Rezoning Transportation Analysis

Petition Number 2016-094 Updated 5/19/2016

Location Approximately 0.82 acres located on the east side of Johnston Road between

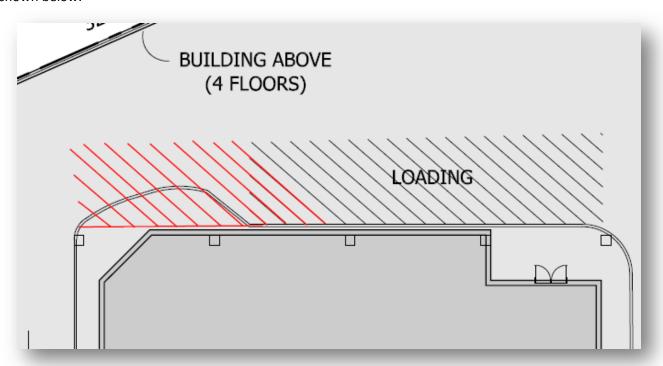
- 1. The petitioner should revise the site plan to reflect driveway layout that will likely be required in permitting type II modified per Charlotte Land Development Standard 10.25E.
- 2. The petitioner should revise the site plan to show right of way dedication 2' behind back of sidewalk.
- 3. The petitioner should revise the site plan to extend the loading zone area for extra truck stacking as shown below.
